ENGINE - AIR - REPLACE THE HP COMPRESSOR VARIABLE STATOR VANE ACTUATOR BRACKET ASSEMBLY
- CATEGORY CODE 6 - MOD.ENG-75-0034

V2500-ENG-75-0034

SERVICE BULLETIN

Location of the bracket assembly
Fig.1

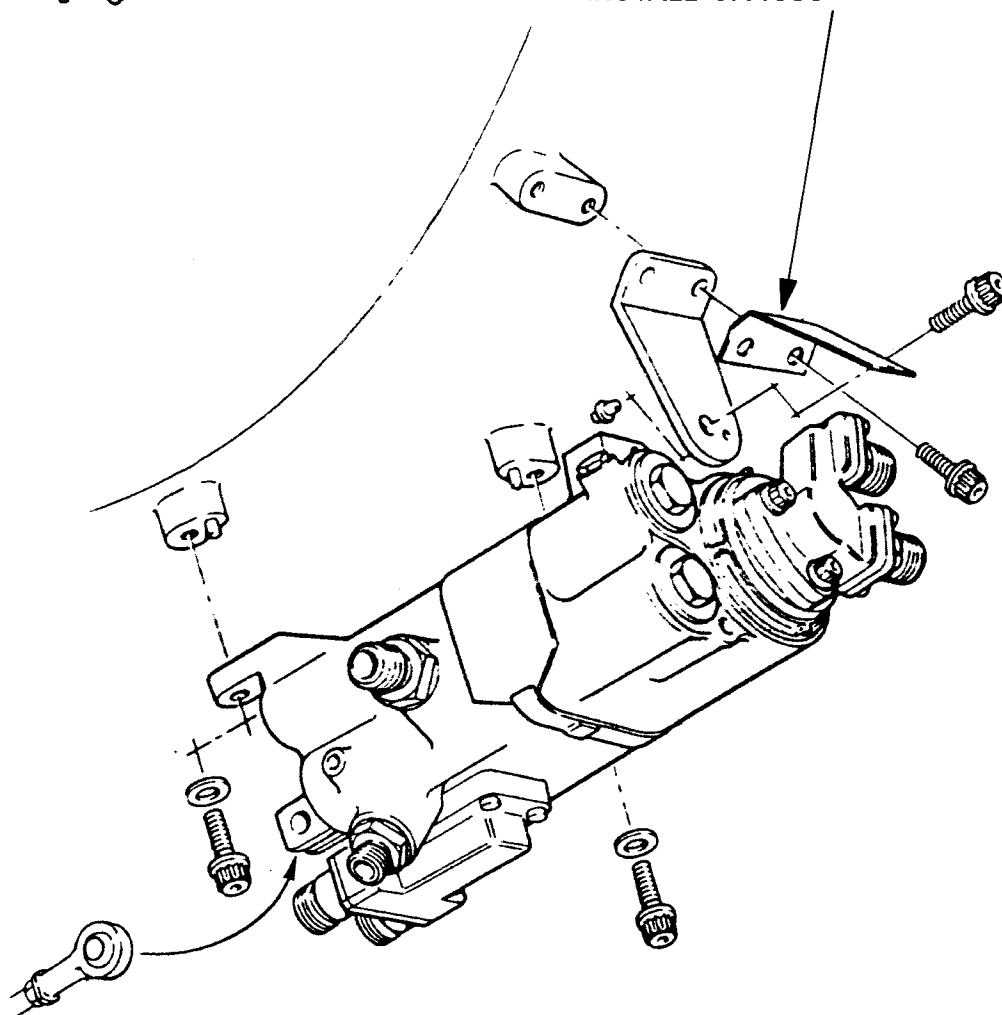
The existing bracket which supports a raceway at clip point 5746 and the EEC harness at clip point 5745 is replaced with a new bracket which is shorter. This change increases the clearance between clip point 5745 and the 'C' duct. The bracket also feature a lip to provide positive orientation of the clip and ensure clearance between the master BSBVA actuator harness disconnect and the EEC harness loom.

REMOVE 5W8366 OR 6A4672 AND
INSTALL 6A4659

- (1) Install the 6A4659 support bracket by means of approved procedures. Refer to A320 Aircraft Maintenance Manual.
